Additional Field Welding Relieving Angle Details

Revisions			
No.	Date	Description	
1	31-07-06	UPDATED TO SUIT APPROVAL	
 <b>NOVEL IRON WORKS</b> 250 Ocean Road Greenland, NH 03840			
Project	Maine Medical Center	Hold	ASCC Certified Category III
Subcontract	Sections & Details	Hold	ER705
Architect	TRO	Drawn By	JL
Engineer	Simpson Gumpertz & Heger Inc.	Check By	M.J.L.
Customer	WILLIAM BERRY & SON, INC.	Job No.	316
		Sheet	E17

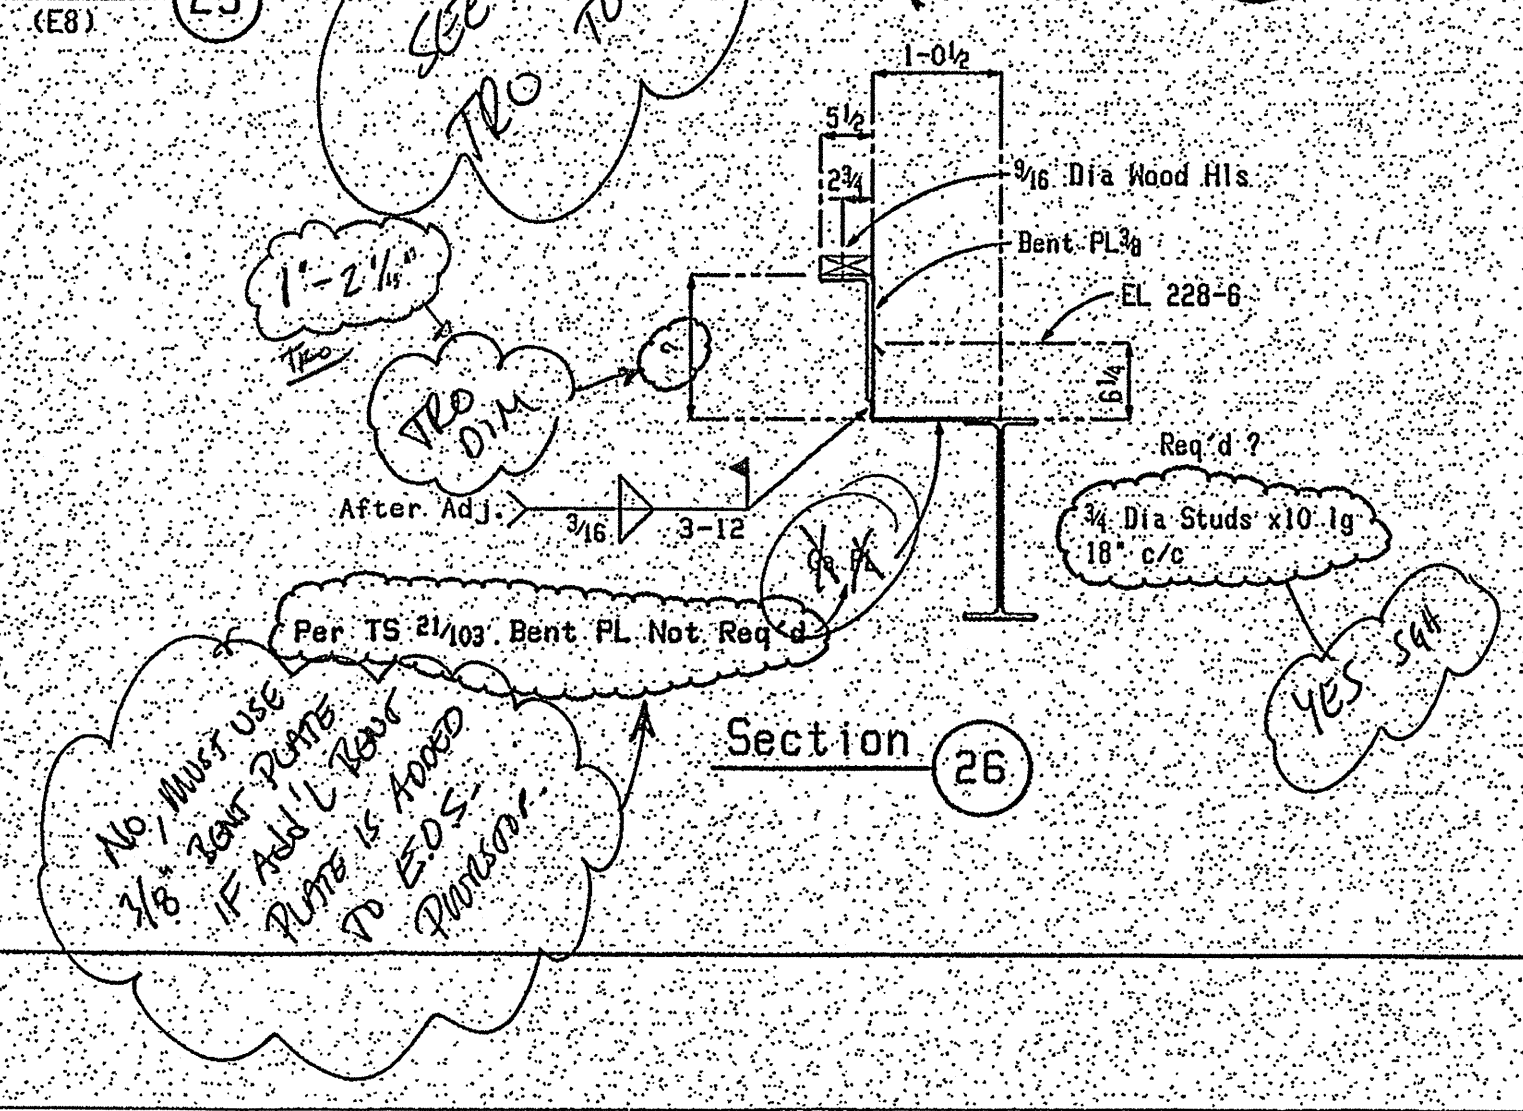
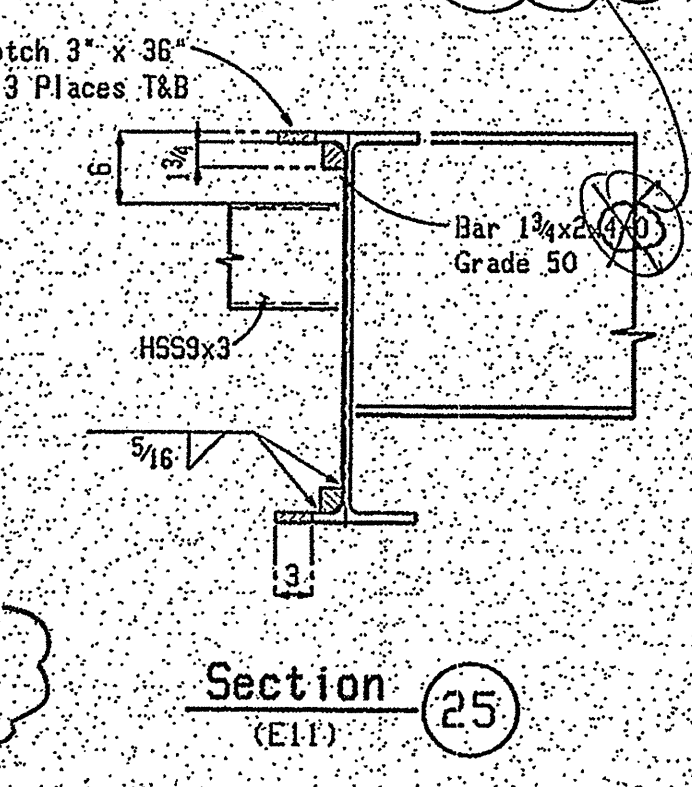
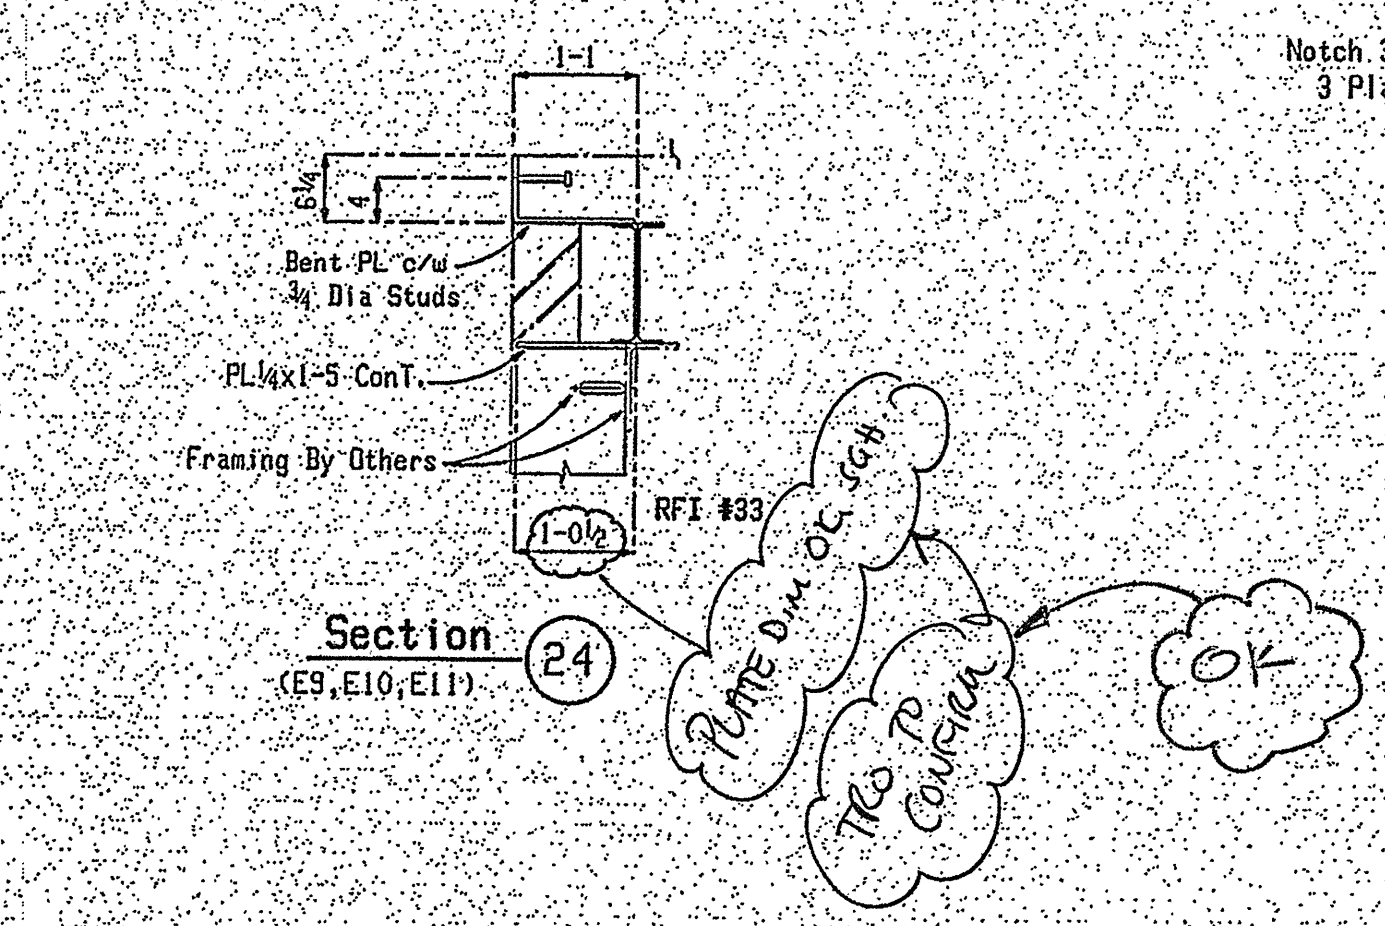
PPC RFI #33, SLEP-02  
3/16" EXTENSION (COUNT) FULL  
LENGTH OF BEAM ABOVE  
STOP 2' FROM FROM END  
END OF TIE BAR

SEE DETAIL F/ASLI  
TRO TO PROVIDE EXTENT ON ROOF PLAN E13

SEE NOTE ON E13  
TRO

PPC RFI #33  
TRO TO CONFIRM  
OK

No. Must Use  
3/8" Rod Ropes  
Ropes is Moved  
TO E10  
Thinking
